**CITY OF NAPOLEON  
BUILDING CONSTRUCTION PERMIT  
(1, 2 or 3 Family Dwelling)**

CITY OF NAPOLEON  
ENGINEERING DEPARTMENT  
APPLICATION FOR ELECTRICAL PERMIT  
(PLEASE PRINT OR TYPE)

To: Norman Howes From: Ron Sonnenberg  
Subject: Service Entrances @ 408 W. Maumee Ave.

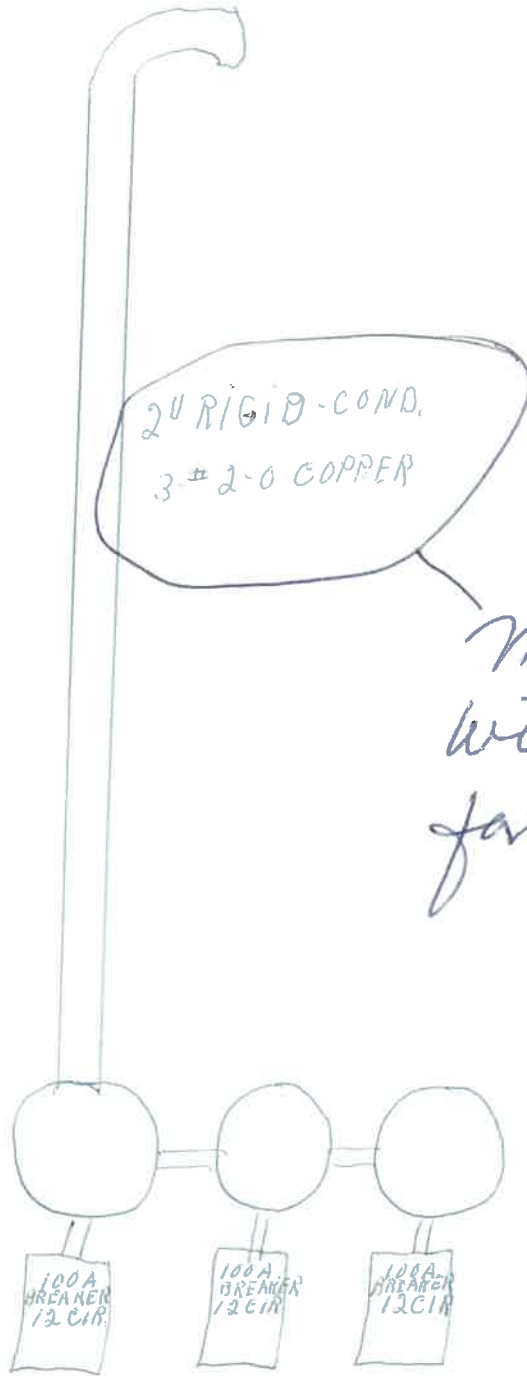
Make sure 2/0  
will carry load  
for 3 apts.

SINGLE-METER-NOW - WILL USE 1 METER CAP-2 METER-SOCKETS  
WHEN-EVER - CUSTOMER-MAKES-CHANGES - USE-METERS-AS-NEEDED.

2nd & 3rd meter socket installed
